SECTION 16 PLANNING APPLICATION

Proposed Temporary Open Storage of Construction Materials with ancillary office and metal scaffold display for a period of 3 years in “Other Specified Uses (OU) - Railway Reserve” zone, Lot Nos. 49s.BRP(part), 50s.B(part), 51RP(part), 379s.B(part), 383(part), 384RP(part), 385RP(part), 392s.B(part), 394s.ARP(part), 394s.C(part), 395(part), 396(part), 397RP, 398, 399RP, 401RP in DD 107 and adjoining Government Land, San Tam Road, Kam Tin, Yuen Long, New Territories

With reference to the emails from various departments, please find the responses to comments in tabulated format for your information.

Appendix A
revised FSI Layout Plan

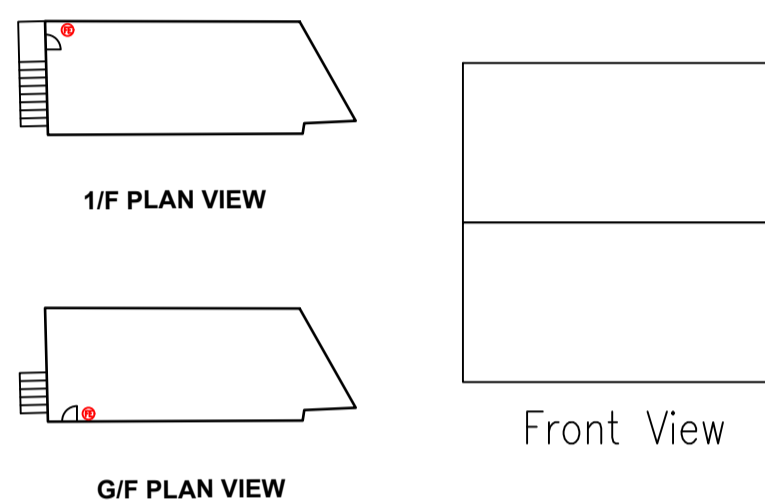
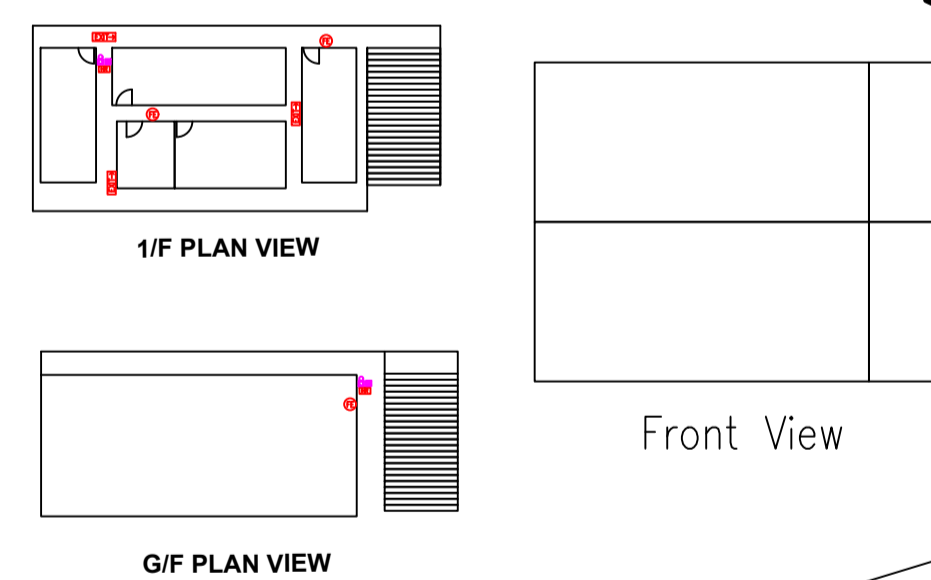
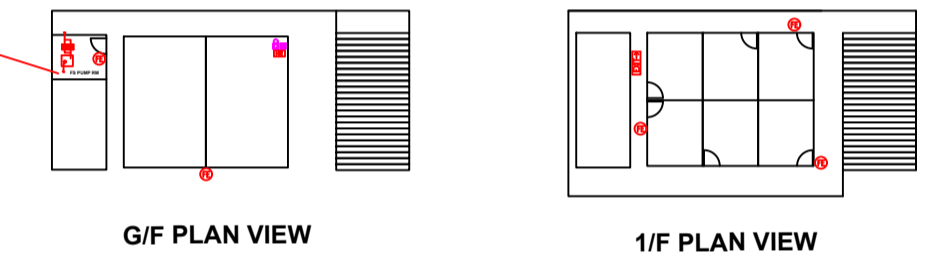
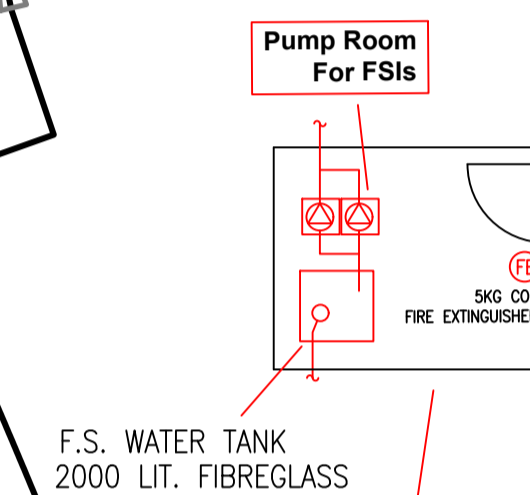
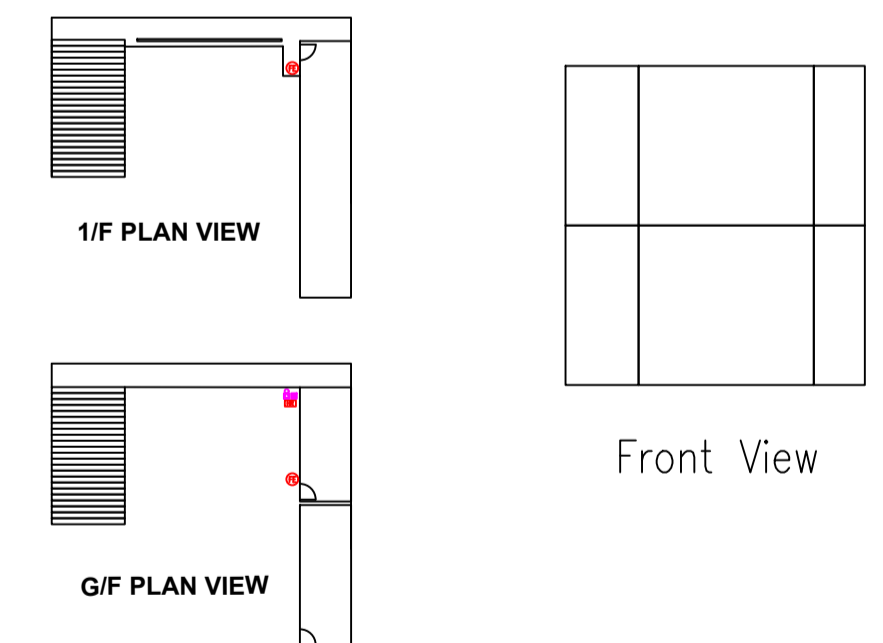
Comments from Fire Services Department (Contact Person: Mr. YUEN Tsz-fung, Tel.: 2733 7737) dated 19 July 2024	
Sprinkler system, modified hose reel system, fire alarm system, emergency lighting, directional and exit sign and portable fire extinguisher shall be provided to any structure with total floor area exceeds 230m ² .	Noted. To have better site management, the covered structure as an ancillary office and metal structure storage has been divided into three components and the FSI has been proposed for each component to suit the needs.

Besides, the revised justification and layout on the provision of FSI proposal (Appendix D and Appendix E, respectively) are enclosed for your reference. Should there be any question or require further information, please don't hesitate to contact the undersigned at tel.

Appendix B
sketch of swept path

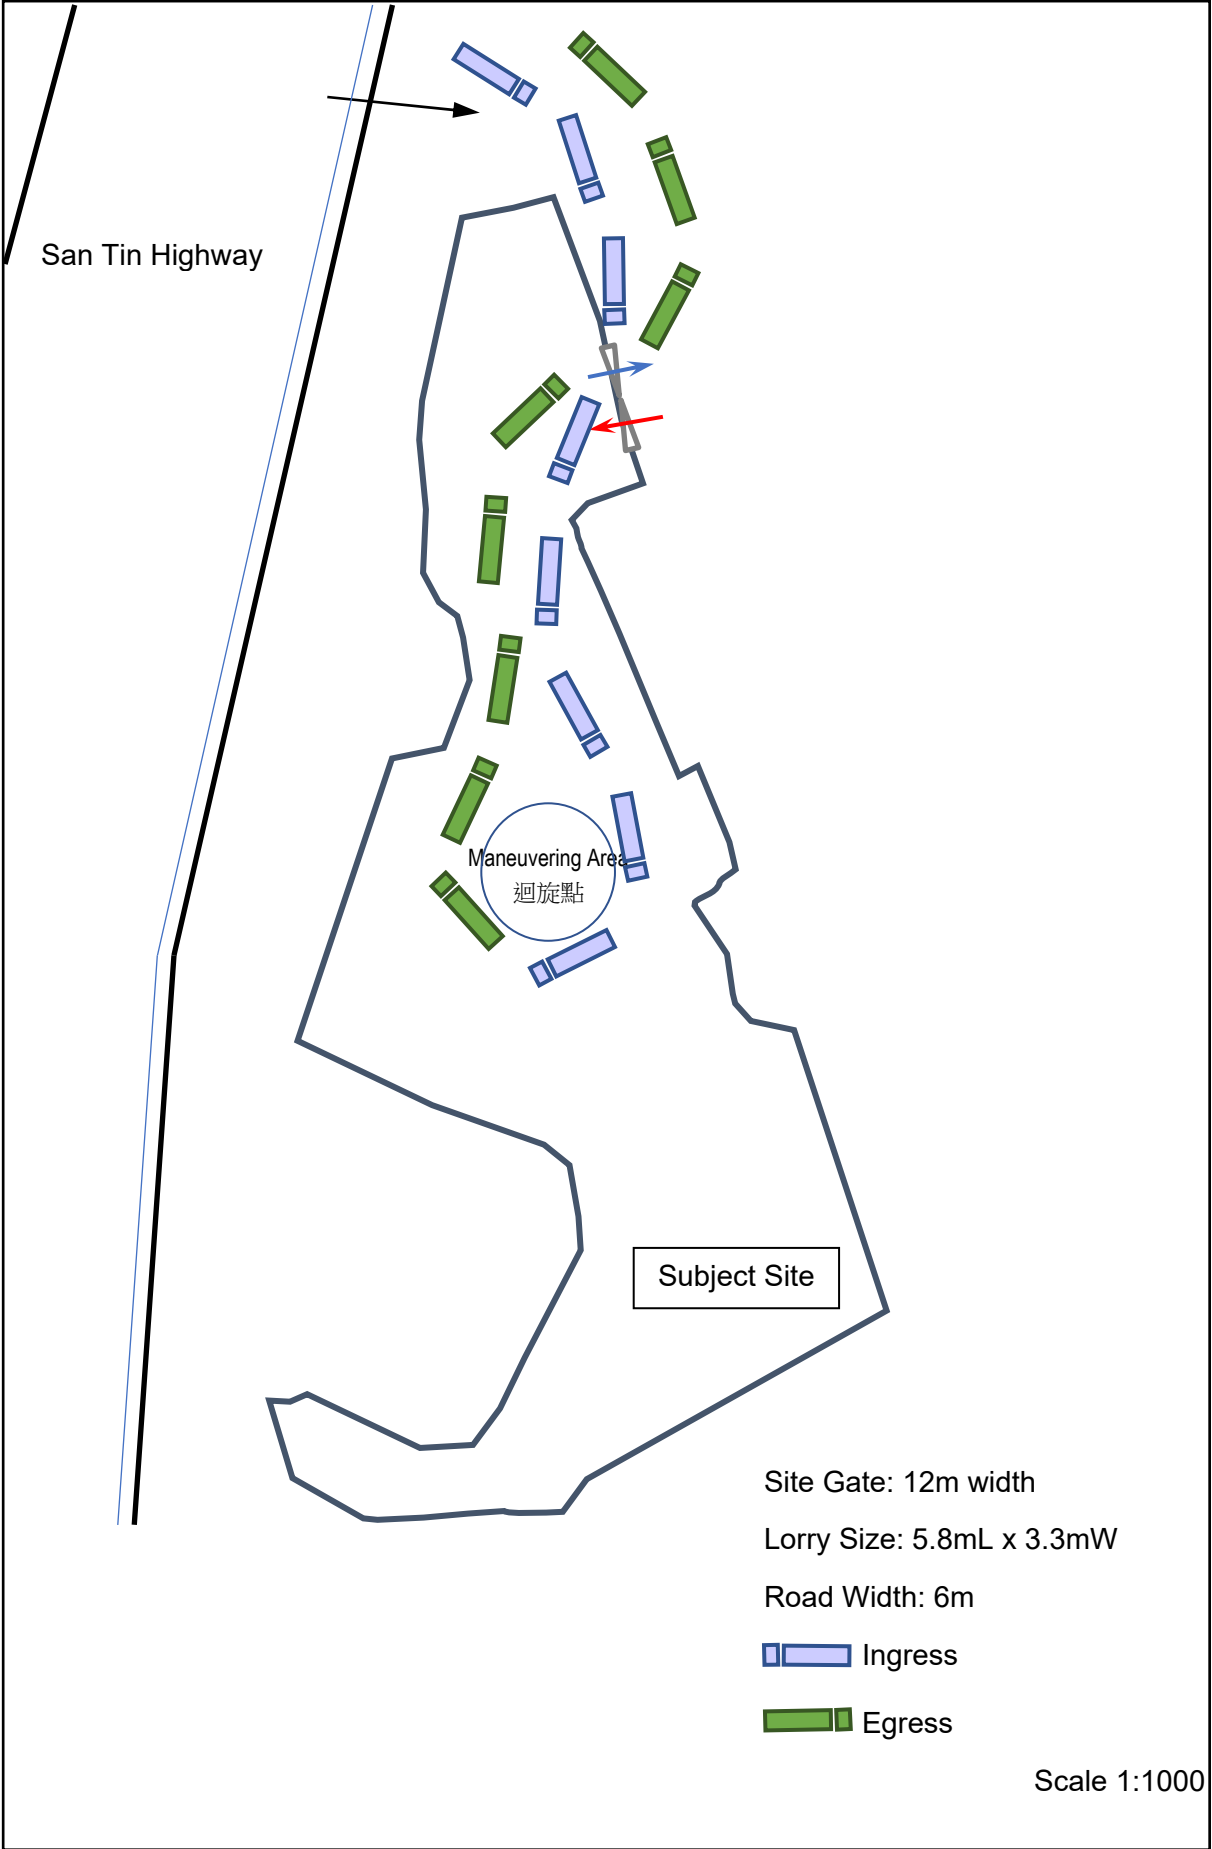
Comment	Response
Comments from Transport Department (Contact Person: Mr. Phil CAI, Tel.: 2399 2421) dated 15 July 2024	
Provision of dimensions of local access, vehicles etc. are not sufficient to demonstrate the smooth manoeuvring of vehicles. The applicant shall provide further information such as swept path, site photos etc.	The size of manoeuvring space is 6.0m in radius. Also, the site is being in operation, hence it was concluded that sufficient space could be provided a smooth moving to the vehicles which visit the Subject Site and bending on local access road. Demonstration of vehicular ingress/egress and the details of entrance have been shown in the attached figure. (Appendix B)
Comments from Fanling, Sheung Shui & Yuen Long East District Planning Office (Contact Person: Ms Andrea YAN at 3168 4049) dated 16 July 2024	
The applicant claims in the submission that the drainage facilities implemented under the previous Planning Application No. A/YL-KTN/825, please provide the records of the existing drainage facilities on site.	Noted and provided. (Appendix C)

Appendix E
revised Schematic Layout Plan

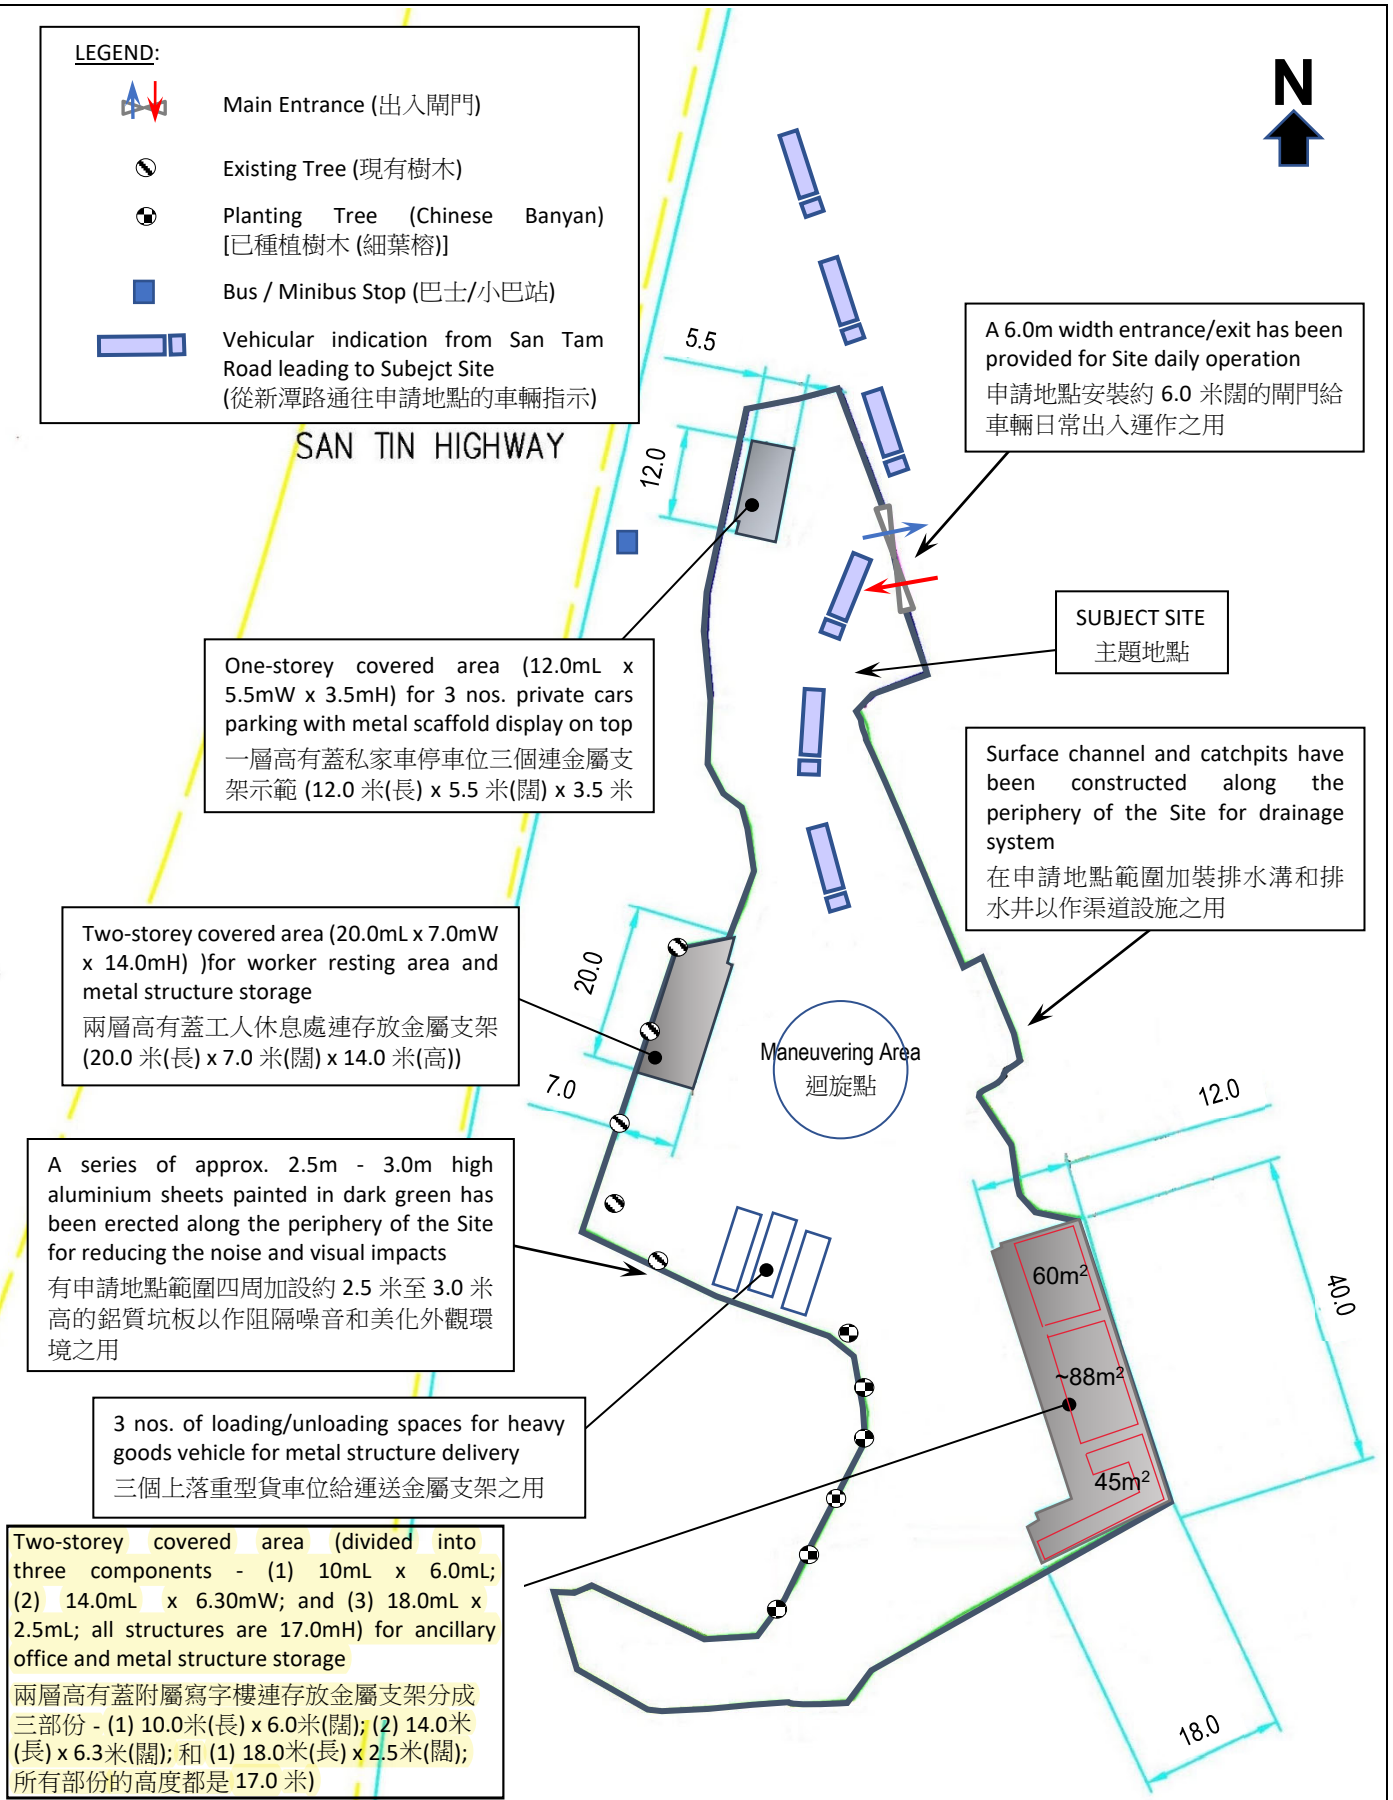
Comments from Fire Services Department (Contact Person: Mr. YUEN Tsz-fung, Tel.: 2733 7737) dated 3 July 2024	
i. All accessible areas on 1/F are GFA accountable. In this regard, detailed layout plans and section drawings shall be provided for our further consideration;	Noted. All accessible areas on 1/F have been marked in the revised FSI Layout Plan. (Appendix A)
ii. Fire extinguishers shall be provided to every level of every structure;	Noted. The provision of fire extinguishers has been indicated in the revised FSI Layout Plan. (Appendix A)
iii. The FS water tank, FS pump room and hose reel shall be clearly marked on plans.	Noted. The concerned FS components have been clearly marked in the revised FSI Layout Plan. (Appendix A)
Comments from Electrical and Mechanical Services Department (Contact Person: Mr. Tong WK TSE, Tel.: 2808 3874) dated 5 July 2024	
Please note that there is a high-pressure underground town gas transmission pipeline in the vicinity of the proposed ancillary office and temporary open storage. In this connection, please provide an estimation of aggregated population induced from the captioned proposal for our consideration. Your attention is drawn that risk assessment would be required from the project proponent/consultant to assess the risks posed by the gas installation if the proposal will result in a significant increase in population.	Noted. As the proposed development is classified as business use (temporary open storage of construction materials with an ancillary office), the aggregated population induced is rarely low, approximately 10 persons per day (Mondays to Saturdays); and zero on Sundays and public holidays since the proposed development is closed. In this context, there is no significant increase in population, and the risk assessment posed by the gas installation could be concluded as not required.
